1U solution for Intel LGA1150 LGA1155 LGA1156 Xeon 1230 CPU Socket clip
April 12, 2019

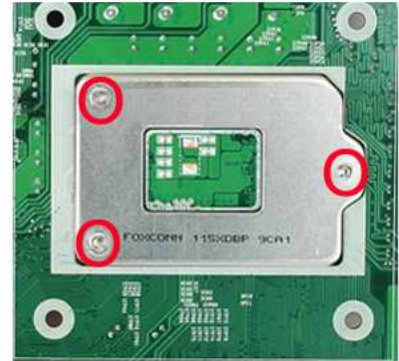
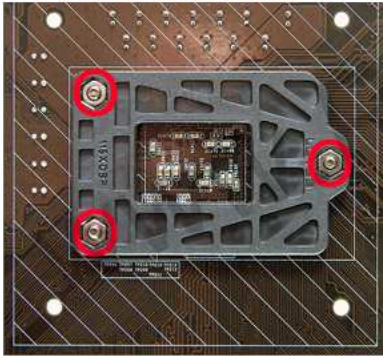
- Solution 1: Shorten the 3 screws at back side of motherboard, see above RED circles
- Solution 2: or Drill 3 holes at bottom of 1U chassis in order to accommodate the longer screws
- Solution 3: If neither the 1st nor the 2nd solution, please order some #6 x 6mm high screws and some 5mm high plastic stand-off, see the photo below.
